UNITED STATES PATENT AND TRADEMARK OFFICE

10/575,507

Office Action Summary	Application No. 10/575,507	Applicant(s) GRASMUCK, GILBERT	
	Examiner KATHRYN D. SHEIKH	Art Unit 3764

DETAILED ACTION

fig. 1

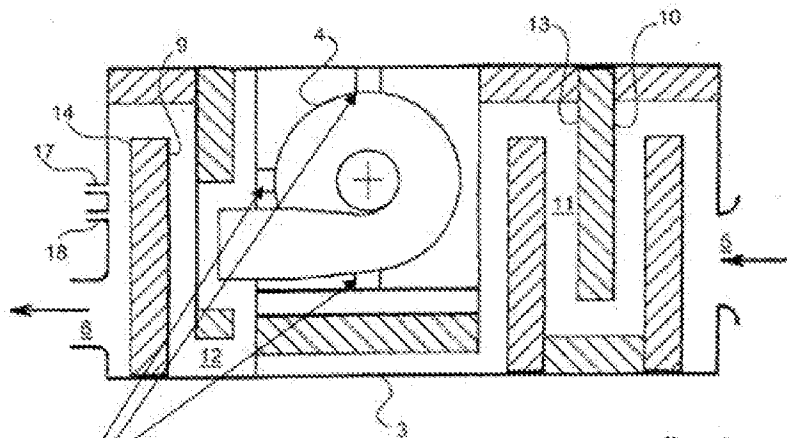
The drawings are objected to under 37 CFR 1.83(a). The drawings must show every feature of the invention specified in the claims. Therefore, the flexible element intercalated between said volute and dynamic assembly (claim 4) (see annotated Figs. below), intermediary of an impervious material (claim 10), sensors for detecting angular position (claim 13), motor with permanent magnets at a rotor under electronic means (claim 14), and a single volute covering several wheels (claim 17) must be shown or the feature(s) canceled from the claim(s). No new matter should be entered.

The drawings are objected to because a) what appear to be connections or fittings between the volute and the casing are unlabeled (see annotated Figs. below, page 9, para [0042] for discussion); b) the hash marks indicating elastomer material are inconsistent; and c) it is unclear what cross section of Fig. 1 is being presented in Fig. 2 (top view? top view rotated? side view?). Corrected drawing sheets in compliance with 37 CFR 1.121(d) are required in reply to the Office action to avoid abandonment of the application. Any amended replacement drawing sheet should include all of the figures appearing on the immediate prior version of the sheet, even if only one figure is being amended. The figure or figure number of an amended drawing should not be labeled as “amended.” If a drawing figure is to be canceled, the appropriate figure must be removed from the replacement sheet, and where necessary, the remaining figures must be renumbered and appropriate changes made to the brief description of the several

What is this?

fig.2

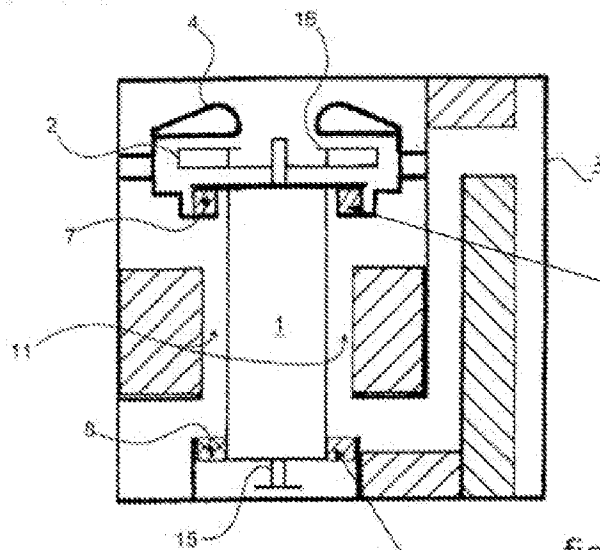
Elastomer not
shown connected to
"dynamic assembly"

Hash marks different than "8"

(modified)
Fig. 3

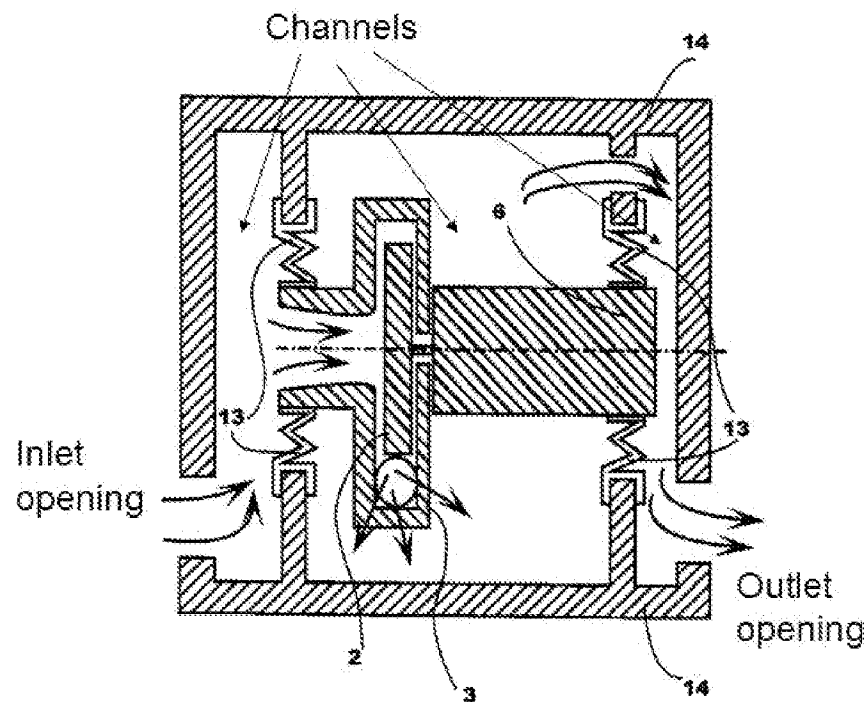
channels circulating a gaseous flux, said channels being arranged inside said casing upstream and downstream of the ventilator (Fig. 3 modified, below), induction and discharge of said gaseous flux through openings of said casing for intake and expulsion respectively, said volute being an integral part of said casing (closed capsule 14 formed in part by the housing 3, column 5, line 13) so as to form an integral fixed assembly; and

Regarding claim 8, Hansmann discloses the device as per claim 1, wherein Hansmann further discloses at least one channel is arranged around the driver (see Fig. 3 modified, above), cooling said driver through a passage of gaseous flow in proximity of said driver.

Regarding claim 9, Hansmann discloses the device as per claim 1, wherein Hansmann further discloses at least one channel is organized in the form of a baffle (Fig. 3 modified, above).
